# CONVEYOR ADVANTAGES

CMA offers “Innovative Advantages” to the CMA Conveyor line. This would be for both the Hi & Lo Temp Standard height and Tall versions. The following describes those “Advantages”:

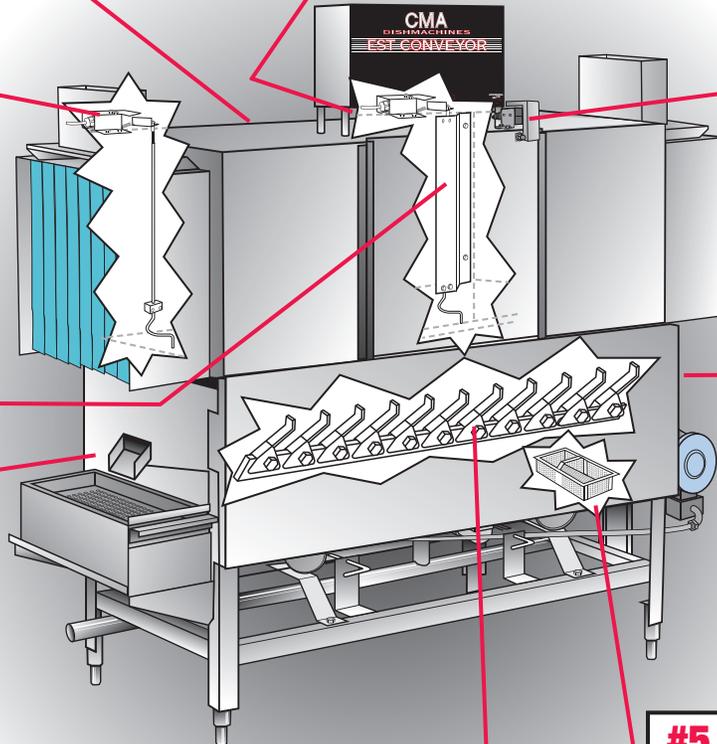
- #1. **Wash Manifold:** A strategically placed pipe from the pump discharge now centered on the manifold, gives balanced wash pressure to both upper and lower wash arms

- #2. **Thermometers:** Strategically located beneath the control panel away from steam path
- #3. **Door Safety Switch:** Replaced magnetic reed switch with a robust mechanical switch

- #4. **Rocker Arm:** Added a second spring to double the pushing capacity of the conveyor (great for heavier dishracks)
- #5. **Scrap Baskets:** Deepened the screens and increased the filtering capacity by 300% to handle more soil (great if poor pre-scraping is taking place)

- #6. **Push Dogs:** Added additional dogs to make the conveyor system more compatible with a wider variety of dish rack brands
- #7. **Wash Tank Heating Element:** Increased the size of the heating element from 10kW to 13.5kW (helpful in accounts with marginal voltage and heat capacity issues)

- #8. **Start and Rinse Activation Rods:**  
Replace magnetic reeds switches with innovative activation rods and robust mechanical switches
